Economic Commission for Europe
Inland Transport Committee
World Forum for Harmonization of Vehicle Regulations
Working Party on General Safety Provisions
123rd session

**Report of the Working Party on General Safety Provisions on
its 123rd session**
Contents

“ Figure 4
Field of Detection

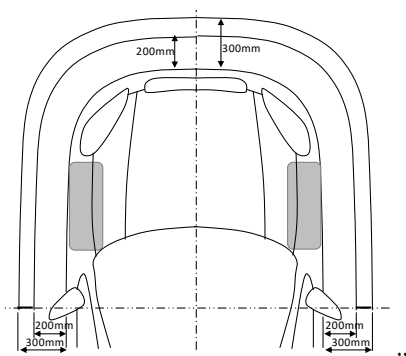
Amendments adopted to ECE/TRANS/WP.29/GRSG/2022/6 (see paragraph 25 of this report)

Paragraph 15.3., Figure 4, amend to replace:

“ Figure 1
Field of detection

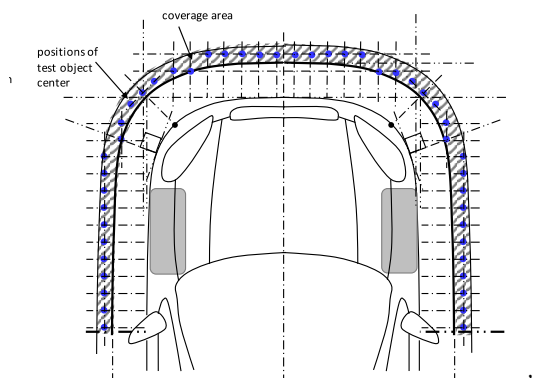
Annex 12, Paragraph 1.3.1., Figure 1, amend to read and replace:
